**Technical Service
BULLETIN**

INSIDE DOOR HANDLE CREAK

'07 FJ Cruiser

NV001-07
H/VH

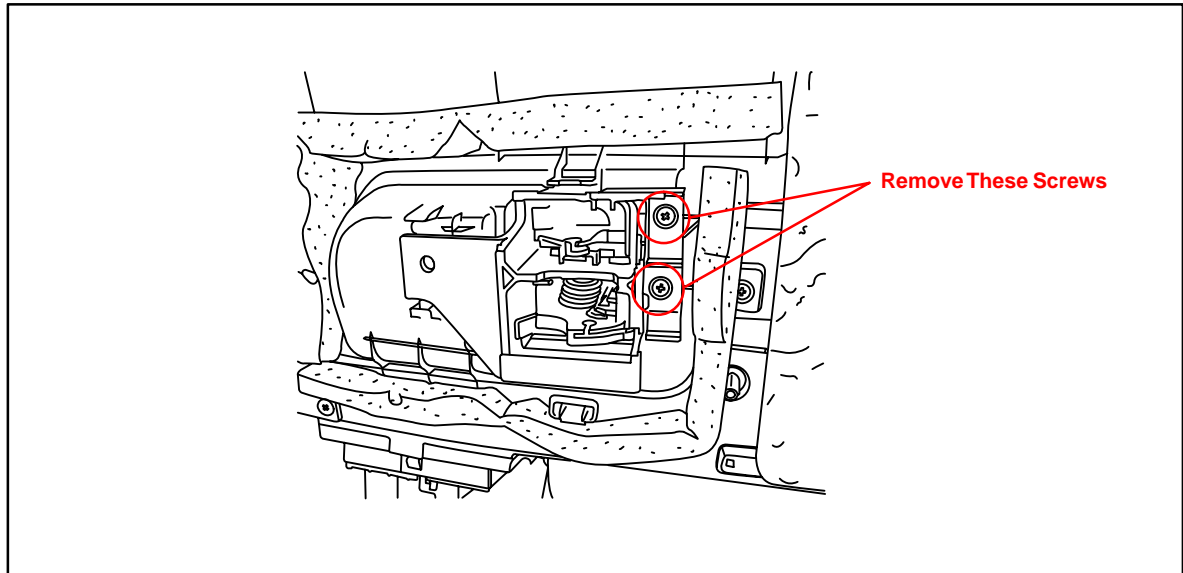
Introduction Some customers may notice a creaking noise coming from the inner door handles when opening the front driver and passenger doors. The door handle assembly has been improved to correct this condition.

2. Remove the two screws and the inside door handle assembly.

3. Install the NEW inside door handle assembly in reverse order and reassemble the door panel.

Be sure to securely fasten the front door lock remote control cable and front door inside locking cable to the handle assembly before reassembly, as shown below.
